U.S. Nuclear Regulatory Commission  
Attn: Document Control Desk  
Washington, DC 20555Limerick Generating Station, Units 1 and 2  
Facility Operating License Nos. NPF-39 and NPF-85  
NRC Docket Nos. 50-352 and 50-353

Subject: Second Ten-Year Interval Inservice Inspection (ISI) Program

**ATTACHMENT**  
**RESPONSE TO JUNE 21, 2001 QUESTIONS**  
**CONCERNING SECOND TEN-YEAR INTERVAL**  
**INSERVICE INSPECTION (ISI) PROGRAM**

**Attachment 2**  
**Core Spray Pump**  
(Typical of 4 for each Unit)  
(Refer to Question 2.2)

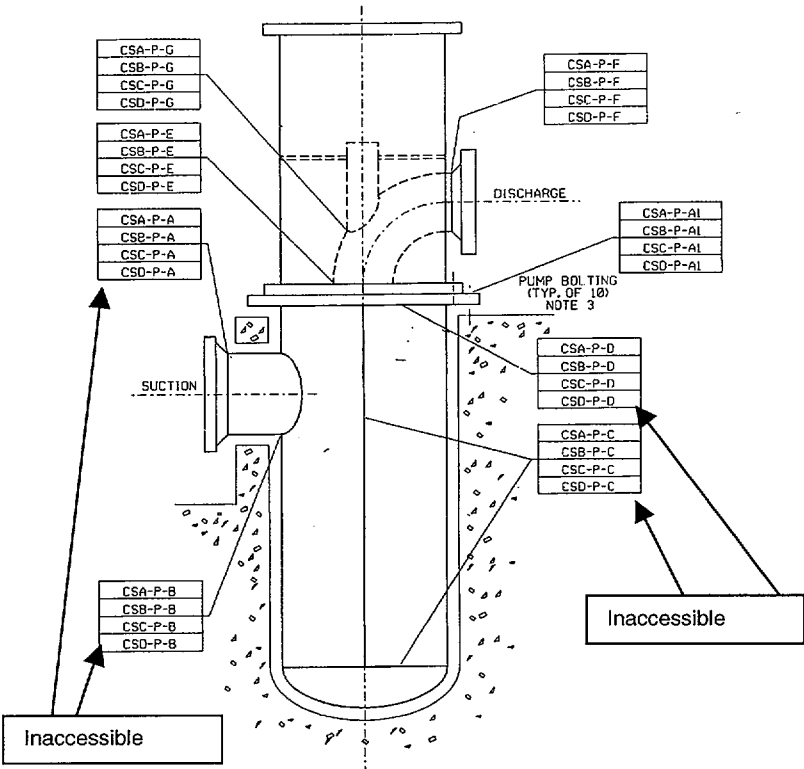
- (1) For all 8 RHR and 8 CS pumps, demonstrate with photos, sketches, and/or drawings that none of the subject pump casing outside surfaces are accessible for surface examination.
- (2) Clarify the statement in the alternate provisions, "The examination method will be determined based on radiation environment data at the time access is enabled." Explain how the examination method to be chosen based on the radiation environment covers the Code required surface of the inside pump casing. Include the maximum and minimum Code-required surfaces that could be examined."

- (1) A sketch showing the physical limitation to the Core Spray (CS) pump and Residual Heat Removal (RHR) pump casing welds is provided in Attachments 2 and 3, respectively.
- (2) The RHR and CS pumps are deep well vertical shaft pumps. The RHR pumps are Ingersoll-Dresser model 34APKD four stage enclosed impeller pumps. The CS pumps are Ingersoll-Dresser model 25APKD six stage enclosed impeller pumps. The number in the model identifier corresponds to the pump diameter. The pumps are supported in the vertical position by a mounting flange that is welded to the shell. The shell, which is fabricated from welded plate, encloses the pumping element and provides for immediate containment of the liquid being pumped. The shell contains a suction nozzle that is flanged for connection to the piping system.

The deep well construction of the pumps has resulted in the outside surface of all shell fabrication welds being encased in concrete. Access to these welds is only enabled from inside the shell when the pump is disassembled and the pumping element is removed. Pump disassembly and removal of the pumping elements results in a significant breach in emergency core cooling system piping. However, when removal is required for pump maintenance or repair, radiological conditions may necessitate leaving the shell filled with water in order to provide a level of shielding to keep dose to personnel as low as reasonably achievable. The shell, filled with water, precludes access to the inside surface of the welds to surface examination techniques; however, remote visual examinations can be performed of the weld and adjacent base metal in accordance with IWA-2210.
